Access Compliance Report

Public Rights-of-Way

Intersection ID: 14600	Main Street: DILWORTH_RD	Cross Street: DILWORTH_RD_EAST	Location: W
ADA ID: 11AF21F20F03	Ramp Type: Perp	Initial Pass/Fail: Fail	Overall Compliance: No
		Severity Score: 12.5

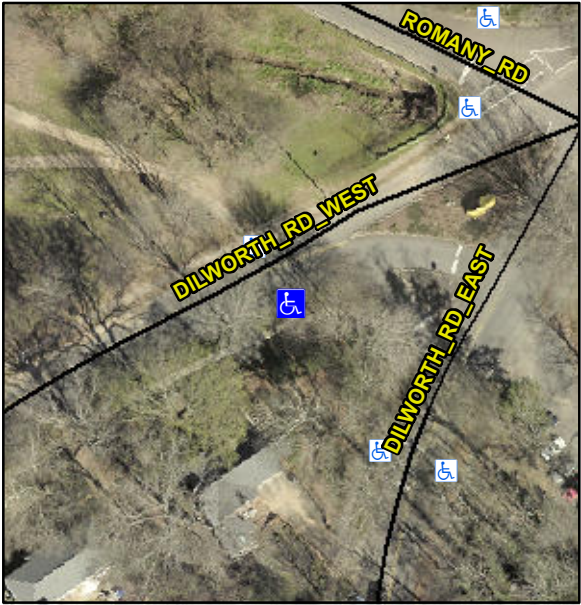
Codes/Mitigation Info/Possible Solution		Field Measurements/Component Compliance					
	Possible Solutions:	Remove & Replace Entire Ramp.					
	Surveyor Notes:	N/A					
	PROW/ADA:	Not Found, R304.2.2					
	Street 1 Name	DILWORTH RD WEST					
	Stop Condition-Street 2	None					
	Street 2 Name	N/A					
	Stop Condition-Street 1	N/A					
	Total Cost:	\$ 1850.00					
		Compliance	Description	Data	Compliance	Description	Data
		N/A	Ramp Length (in)	112.0	No	Ramp Slope (%)	8.7
		Yes	Ramp Width (in)	48.0	Yes	Ramp XSlope (%)	2.0
		N/A	Flare Type LT	N/A	N/A	Flare Type RT	N/A
		N/A	Flare Slope LT (%)	N/A	N/A	Flare Slope RT (%)	N/A
		N/A	Flare Traversable LT?	N/A	N/A	Flare Traversable RT?	N/A
		N/A	Landing Length (in)	N/A	N/A	DWS Provided?	N/A
		N/A	Landing Width (in)	N/A	N/A	DWS Contrast?	N/A
		N/A	Landing Slope (%)	N/A	N/A	DWS Length (in)	N/A
		N/A	Landing X Slope (%)	N/A	N/A	DWS Full Width?	N/A
		N/A	Landing Curb? (Y/N)	N/A	N/A	DWS Offset (in)	N/A

N/A	Shared Landing?	N/A			
		N/A	Gutter Ponding?	Yes	N/A	Gutter Slope (%)	N/A
		N/A	Gutter Lip Ht (in)	N/A	N/A	Gutter X Slope (%)	N/A
		N/A	Painted X Walk1?	No	N/A	Painted X Walk2?	N/A
			X Walk 1 Direction	To N		X Walk 2 Direction	N/A
		N/A	X Walk 1 Width (in)	N/A	N/A	X Walk 2 Width (in)	N/A
			X Walk 1 Slope (%)	8.0		X Walk 2 Slope (%)	N/A
			X Walk 1 X Slope (%)	3.5		X Walk 2 X Slope (%)	N/A
		N/A	Ramp inside XWalk1?	N/A	N/A	Ramp inside XWalk2?	N/A
			Road Slope (%)	N/A	N/A	Clear Space?	N/A
			Road X Slope (%)	N/A	N/A	Clear Space to XWalk (in)	N/A
		N/A	Any Obstructions?	N/A	N/A	Storm Grate/Utility Hazard?	N/A
			Obstruction Type			Storm Grate/Utility Type	
				N/A			N/A
					Yes	Surface Condition? (G/P)	Good
